PCN Number:	20151016001C	PCN Date:	08/2/2016
Title:	Qualification of AMKOR P1 as Additional Assembly and Test Site for Select SOIC Package Devices		
Customer Contact:	PCN Manager	Dept:	Quality Services

Texas Instruments Incorporated is announcing the qualification of AMKOR P1 as Additional Assembly and Test Site for select devices listed in the "Product Affected" Section. Current assembly sites and Material differences are as follows.

Sample product shipping label (not actual product label)

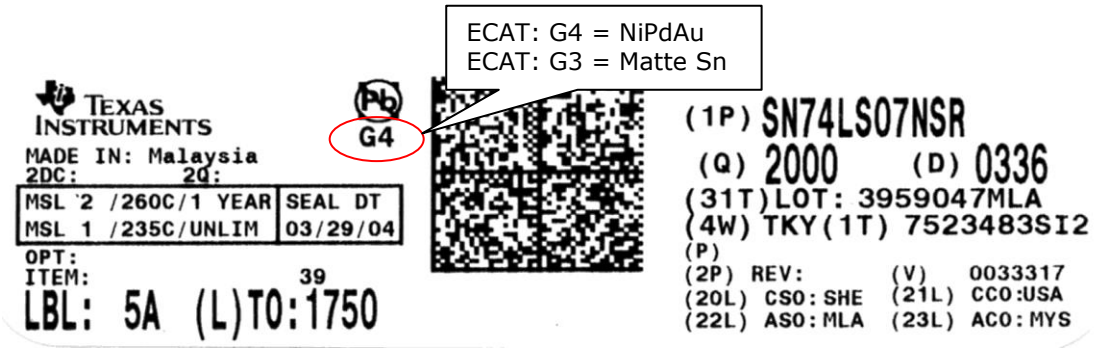
Changes to product identification resulting from this PCN:

Assembly Site			
TI Mexico	Assembly Site Origin (22L)	ASO: MEX	ECAT: G4
TI Malaysia	Assembly Site Origin (22L)	ASO: MLA	ECAT: G4
ASESH	Assembly Site Origin (22L)	ASO: ASH	ECAT: G3
Amkor P1	Assembly Site Origin (22L)	ASO: AKR	ECAT: G3

ASSEMBLY SITE CODES: TI-Mexico = M , TI-Malaysia = K , ASESH = A , AP1 = 4
